KIRKLEES METROPOLITAN COUNCIL

UPDATE OF LIST OF APPLICATIONS TO BE DECIDED BY DISTRICT WIDE PLANNING COMMITTEE

31 October 2024

Application for a Definitive Map Modification Order (DMMO) to record a public footpath at Old Lane, Scapegoat Hill, Colne Valley on the Definitive Map and Statement (DMS), and two other discovered routes

Figure 1 / Figure 41: Replacement draft Order map – Public footpaths recommended to be added (ABCD) dated 16/9/2024

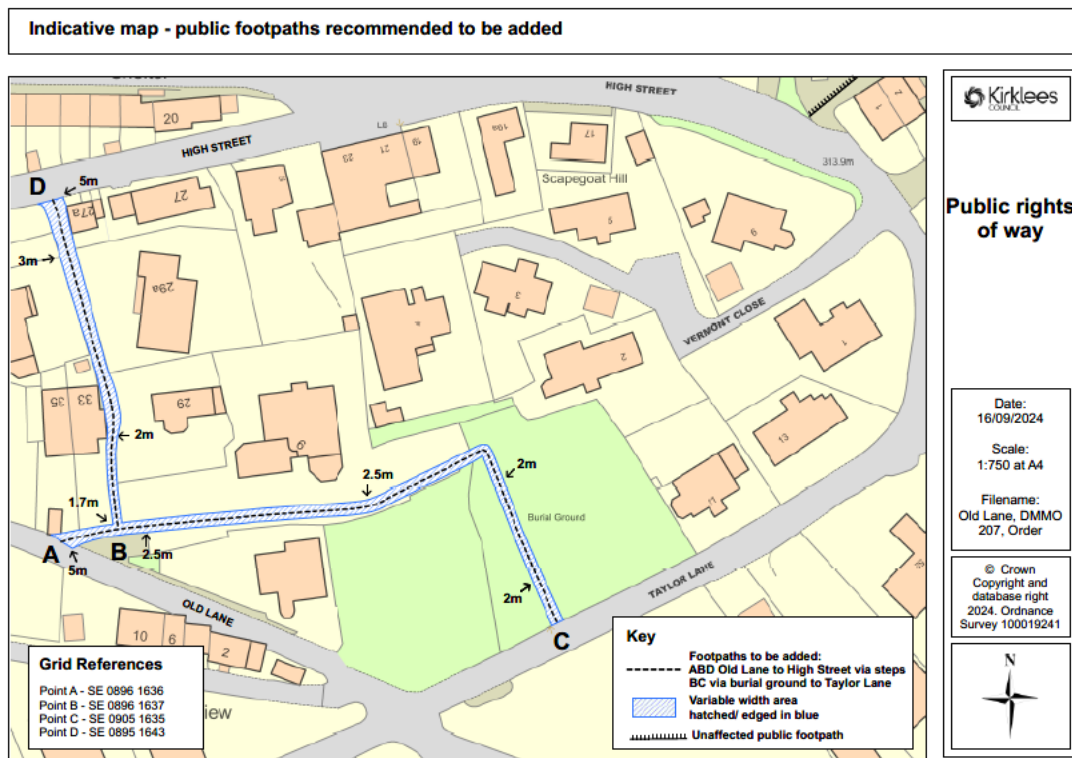
The draft Order Map at **Figure 1, page 17** of the **Committee Report** and the same map at **Figure 41, page 34** of **Appendix C Figures and Photos** has been updated since the report was published on the Council's website in relation to the variable width area hatched/ edge blue with dashed black lines at point A and between B and C.

Officers have since reviewed the boundaries shown on the 2020 OS mastermap in comparison to available aerial photos, such as those taken in 2012, to ensure the correct widths are recommended to be recorded. It has become apparent that the width of route 1 as shown on the 2020 OS mastermap is much wider than the width actually used and enjoyed by the public as of right and without interruption during the relevant period of 1997 to 2017.

The recommended widths have therefore been revised, reducing the width at Point A on the draft Order map from 9.5 metres to 5 metres, where route 1 commenced between a garage on the northern side and an old drystone wall on the southern side. The width has also been reduced between Points B to C from a variable width between 4.8 and 2.9, to a consistent 2.5 metre width between historic drystone wall boundaries. Along the burial ground steps it continues with a width of 2m.
